**TRAFFIC CIRCULATION LAYOUT CHECKLIST**

Re: T.C.L. submittal (3<sup>rd</sup>) for building permit approval for BDA Architecture Office Building,  
901 Lamberton Place N.E. [H15/D040G],  
Architect Stamp dated 5/25/2001.

The location referenced above is not acceptable and requires modification to the Traffic Circulation Layout (T.C.L.) prior to Building Permit release as stated on the attached TCL checklist, and red-lined T.C.L. markup with comments.

Exhibit

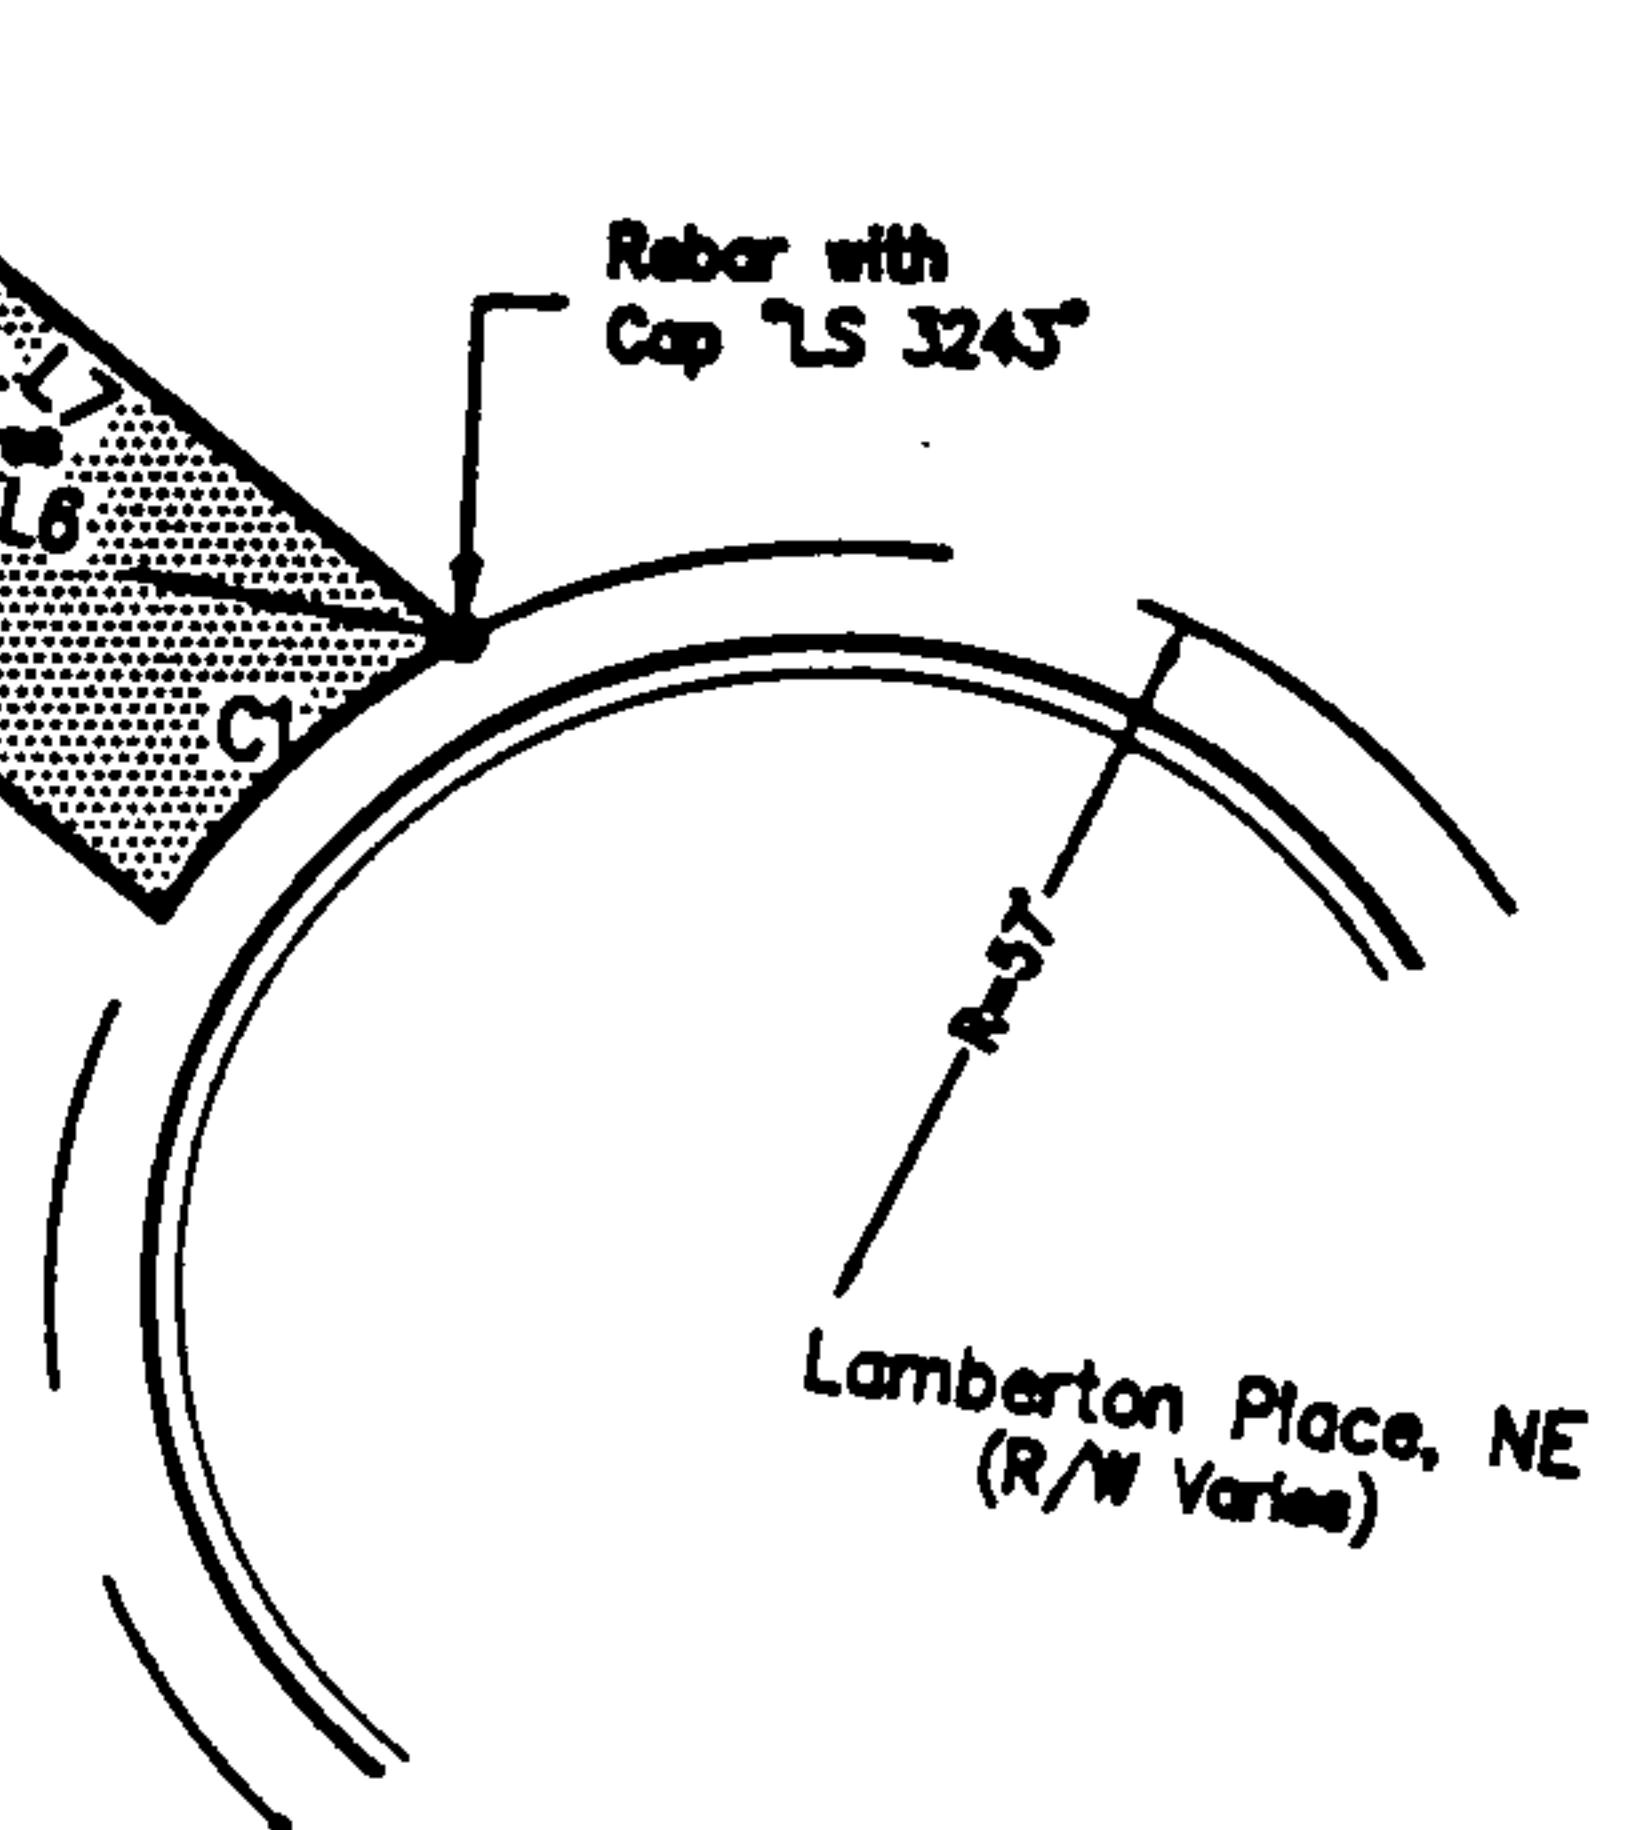
*Mr. Vsiak,*

*should  
The easements ~~that~~ be recorded & filed at  
the County Clerk's office.*
